CITY OF WEST DES MOINES
CITY COUNCIL MEETING COMMUNICATION

ITEM: Eldorado Estates, 1450 S. Jordan Creek Parkway – Subdivide property into 14 lots for single family development, 1 street lot, and 1 outlot – Chayse Holdings, LLC – PP-002787-2015

RESOLUTION: Approval of Preliminary Plat

CITY OF WEST DES MOINES
PLAN AND ZONING COMMISSION COMMUNICATION

ELDORADO ESTATES
S. JORDAN CREEK PARKWAY
PRELIMINARY PLAT LAYOUT PLAN

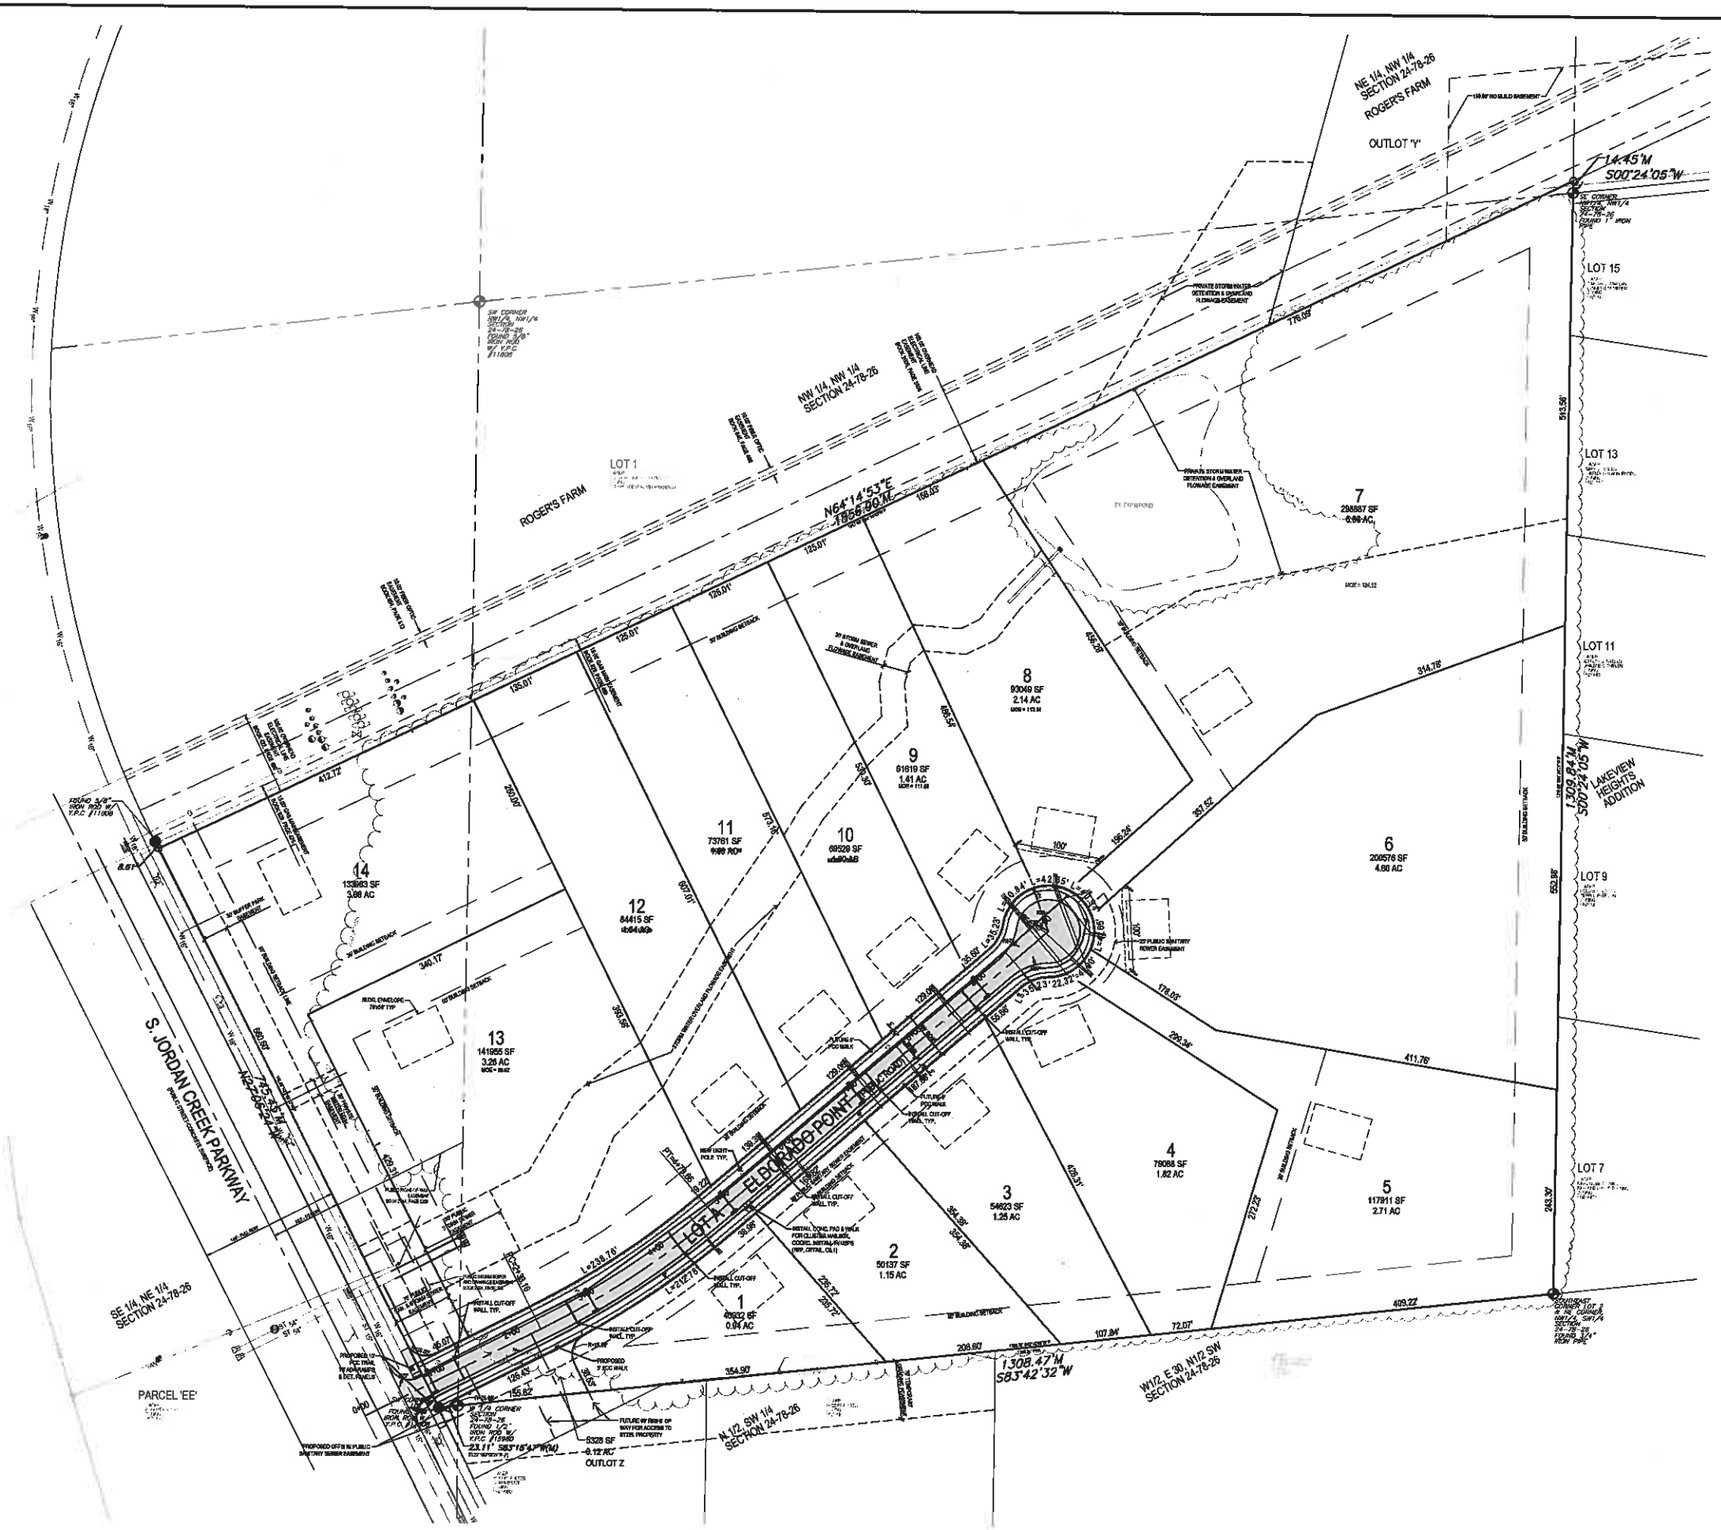
Plan and Zoning Commission Discussion:
The Plan & Zoning Commission discussed adding a 35' building setback requirement along the west property line of Lot 13 to keep the home away from the future driveway to Lot 14 and to help in aligning the homes on Lots 13 and 14. The Plan & Zoning Commission voted to approve the plat with the addition of a 35' setback along the west property line of Lot 13. The applicant agreed to this and has updated the Preliminary Plat accordingly.

PLANTING PLAN: ELDORADO ESTATES
SOUTH JORDAN CREEK PARKWAY
WEST DES MOINES, IA

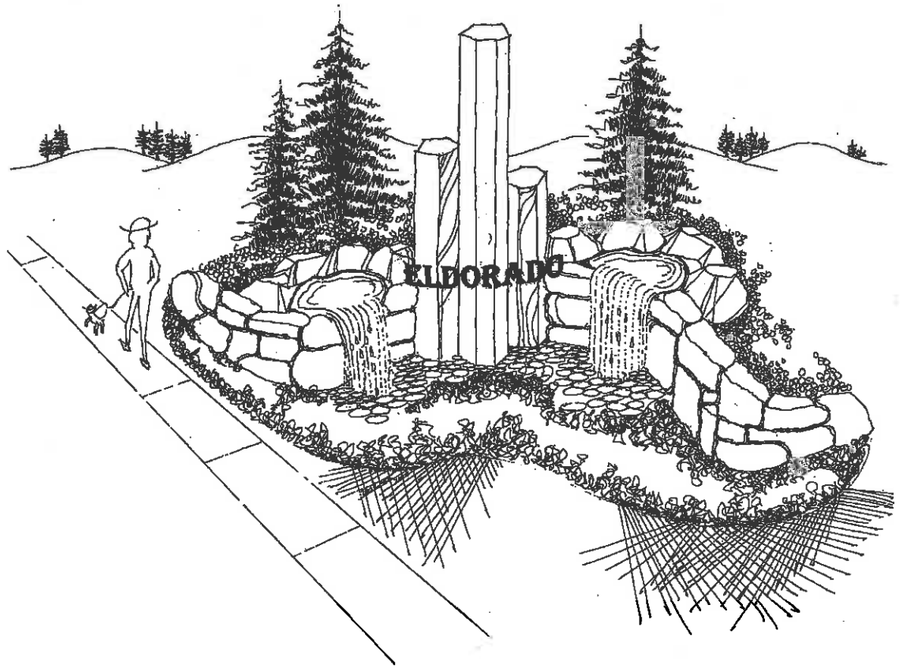
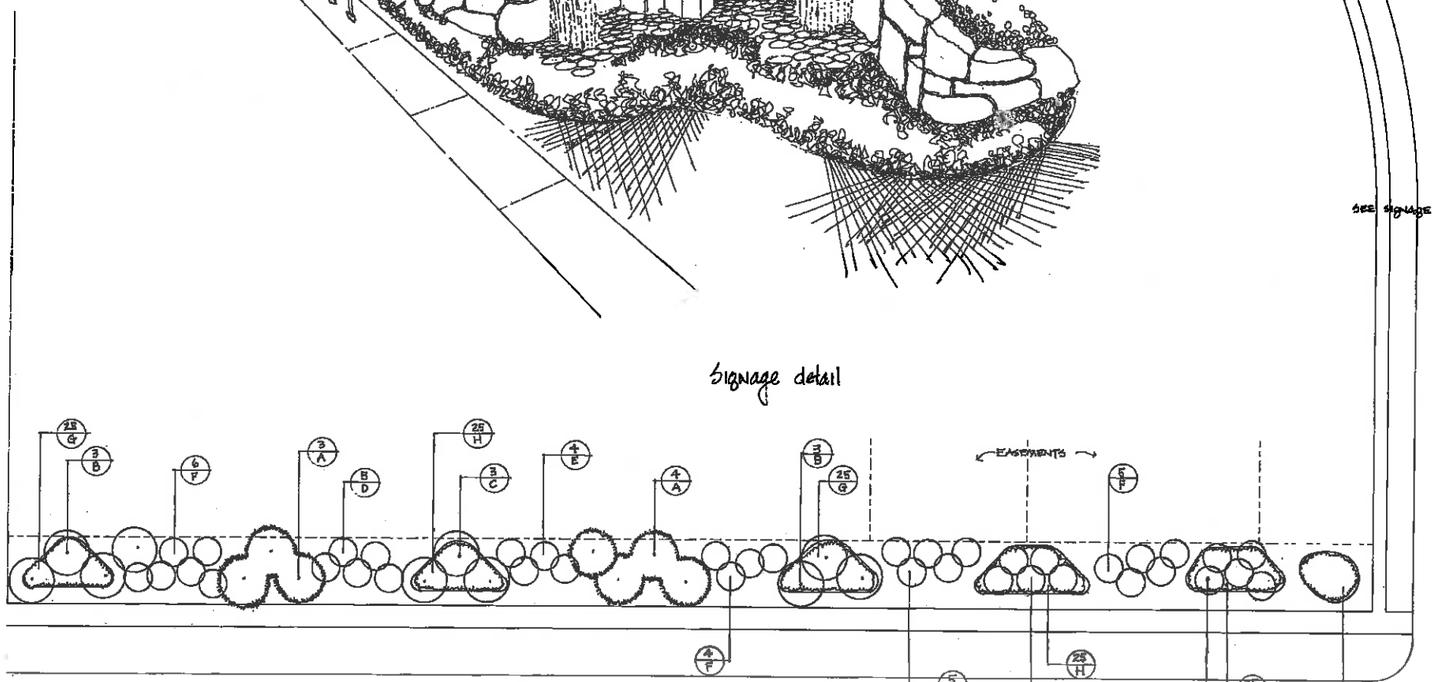
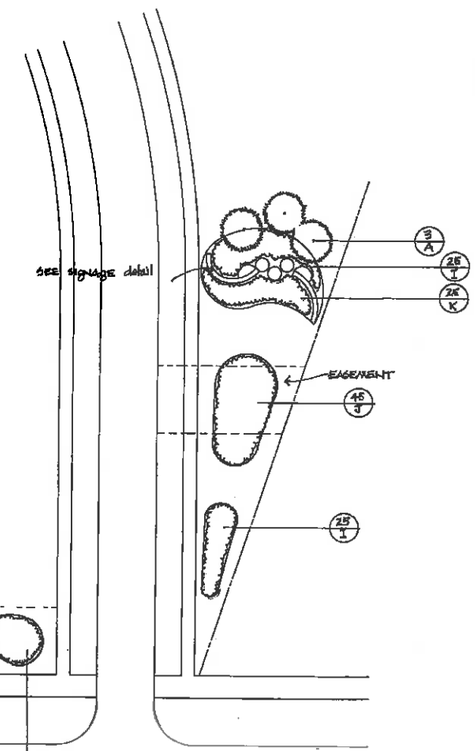
- *Subdivision Sign:* A subdivision sign is proposed and shown on the Landscape Plan that will be located on the southeast corner of the Jordan Creek Parkway and Eldorado Point intersection. This design and location will not be approved through the preliminary platting process. A separate review and approval of a sign permit will be required to erect the sign. A condition of approval of the preliminary plat is recommended to address this.

- *Landscaping on Outlot Z:* Landscaping is indicated on the landscape plan in the area where right-of-way may be dedicated in the future to provide a connection to the property to the south of the subject property. In the

event the right-of-way needs to be dedicated in the future, this landscaping will have to be removed or relocated.

1. The Eldorado Estates subdivision sign as depicted on the Landscape Plan is not approved as part of the Preliminary Plat approval. A separate review and approval of a sign permit shall be required to erect the sign. The sign location shall be located such that it does not interfere with the site triangle of the future intersection of Eldorado Point and the street that connects the property to the south; and

2. The landscaping as depicted on the Landscape Plan within the future right-of-way of the street connecting the property to the south shall be removed by the applicant at such time that the dedication of right-of-way is required to provide a roadway connection to the property to the south.
